Author: Cervera, Lluno	Field Modification Instruction FR2E12 Control Box/Drain holes	FMI 751-140 12/17/20 Rev: 1
---------------------------	--	--

Field Modification Instructions for Project: FR2E12

Modification: Control box replacement and Drain hole addition

Subject: FR2E12 Relay Box/Drain Holes

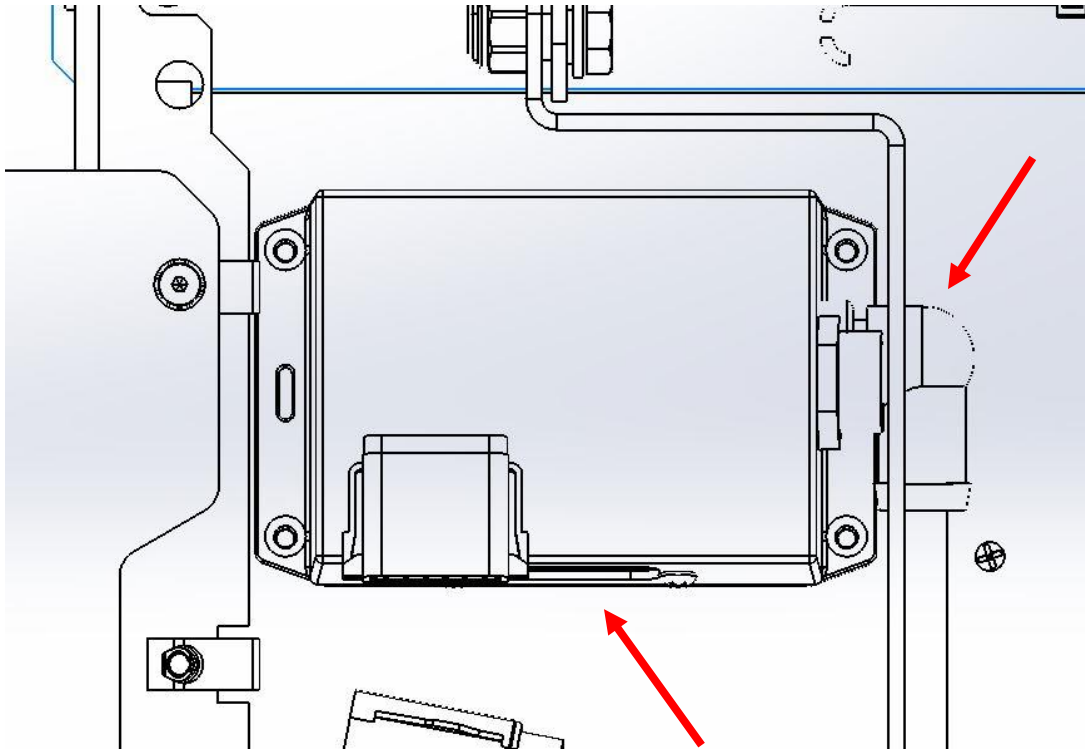
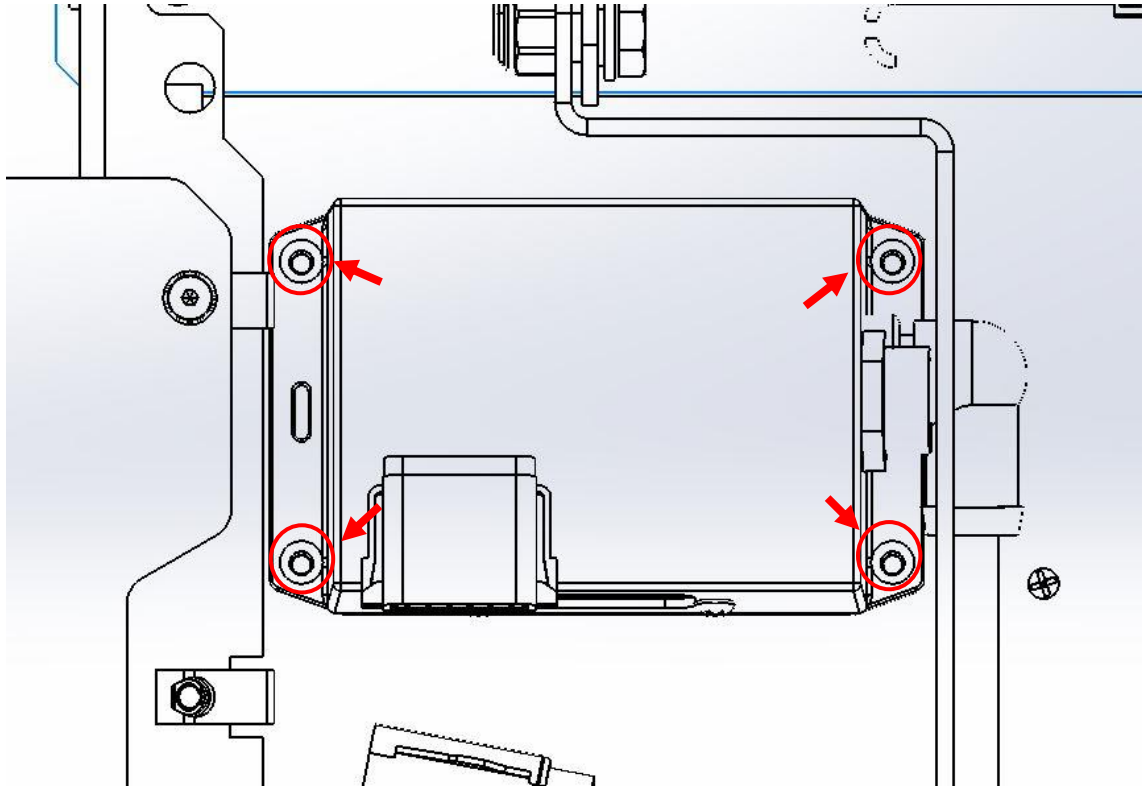
Reason: Water retention in the enclosure due to insufficient drainage is causing water ingress issues with the Control box. Control box to be replaced with an IP64 rated box, and drain holes added to bottom of enclosure for proper drainage.

8. Remove the existing control box 55980. Set aside.
9. Repeat steps in reverse to install replacement control box, 55980 Rev.D. Use medium strength threadlocker on mounting hardware.
10. Re-install connectors onto Control Box ensuring the connectors are positively engaged in their respective receptacles.
11. Do not re-install access cover at this time as adjustments to the ramp timing may be necessary.

Drain Holes

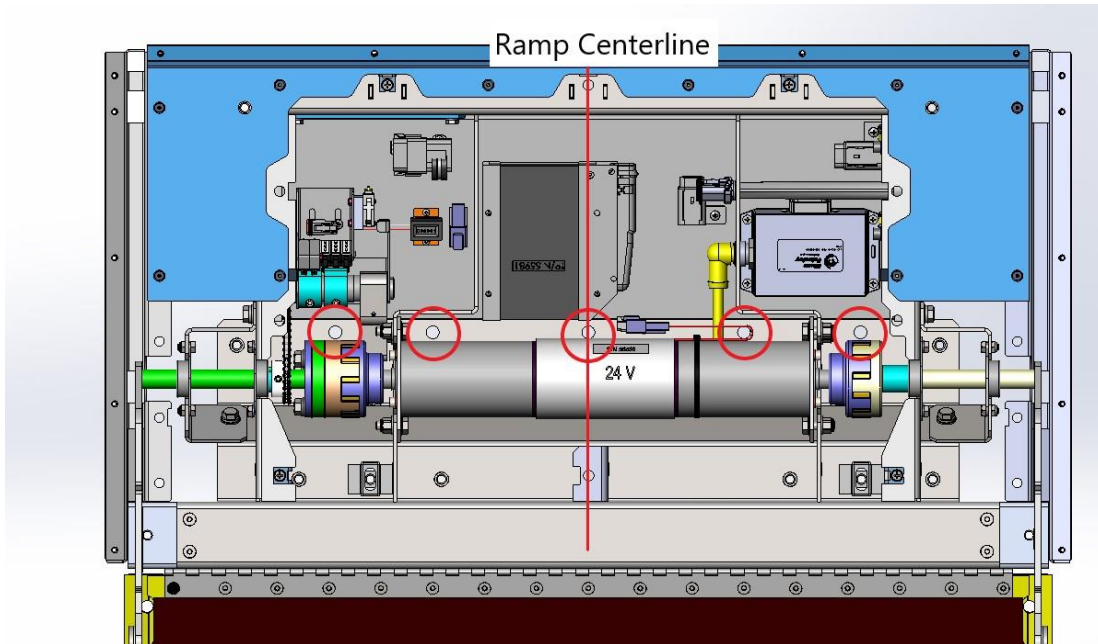
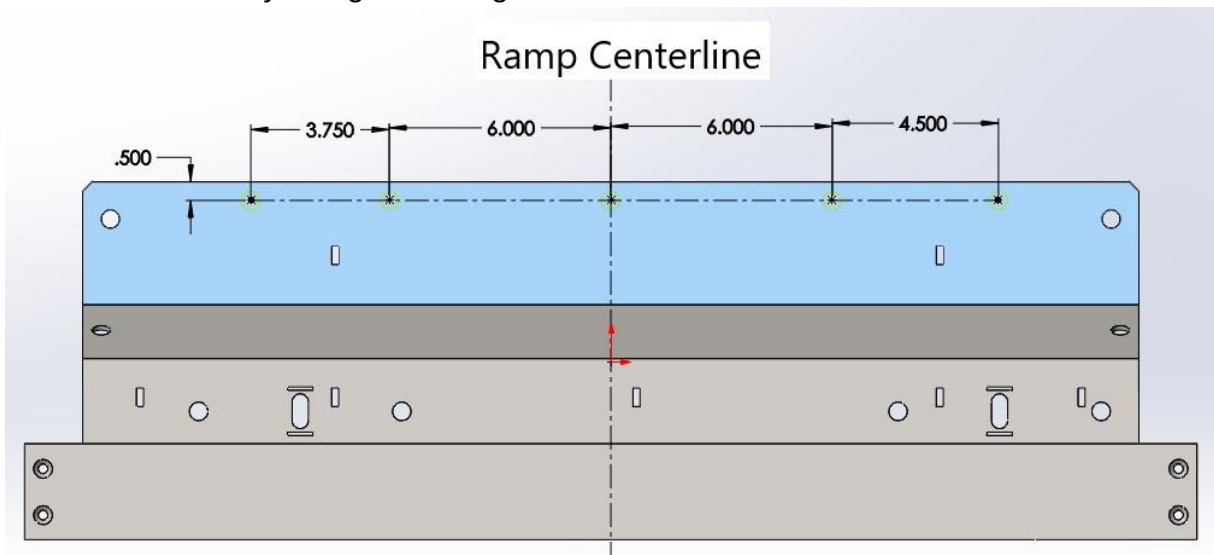
1. With the Ramp access cover removed, drill a total of five drain holes in the bottom enclosure pan in the locations shown below.

2. Starting at the Ramp Centerline, drill a pilot hole at the locations shown below using the 1/8" drill bit.
3. Step up the drill bits until a final hole dimension of 1/2" is achieved. Deburr the holes as necessary using deburring tool.

4. Spray the exposed metal areas of the holes with spray paint. Follow paint manufacturer's instructions for proper curing time before returning to service.
